Access Compliance Report

Public Rights-of-Way

(Curb Ramps)

Intersection ID: 49196	Main Street: GIBBON_TERRACE_CT	Cross Street: GRAYPARK_DR	Location: NE
ADA ID: 57CA026D9AF1	Ramp Type: BlendTrans1	Initial Pass/Fail: Pass	Overall Compliance: No
Severity Score: 20			
Codes/Mitigation Info/Possible Solution		Field Measurements/Component Compliance

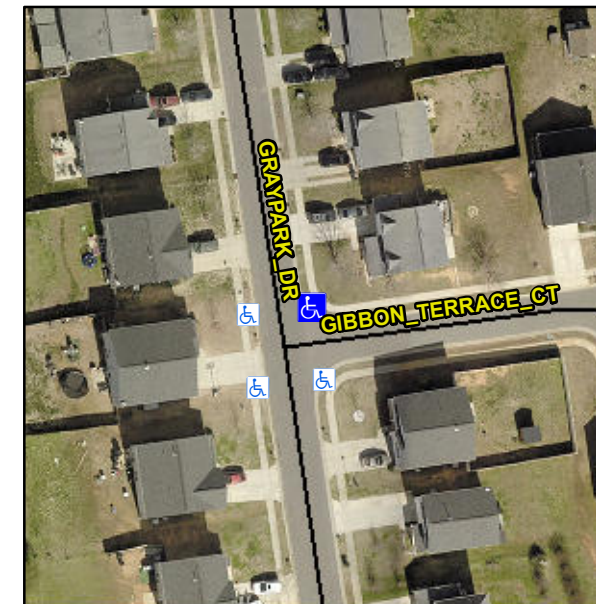
Remove & Replace Curb Ramp With Two New Directional Ramps or Equivalent. Remove & Replace Gutter.

Not Found, R304.2.1, R302.7.2, R304.5.4
